Access Compliance Report

Public Rights-of-Way

Intersection ID: 42838	Main Street: SARDIS_OAKS_RD	Cross Street: SARDIS_RD_NORTH	Location: NW
ADA ID: F407CE9B0643	Ramp Type: Para	Initial Pass/Fail: Fail	Overall Compliance: No
		Severity Score: 12.5

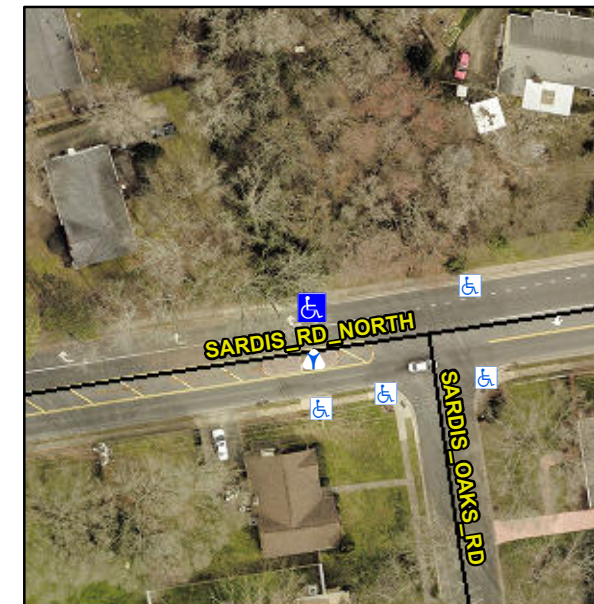
Possible Solutions:

Remove & Replace Entire Ramp.

PROW/ADA:

R304.3.2
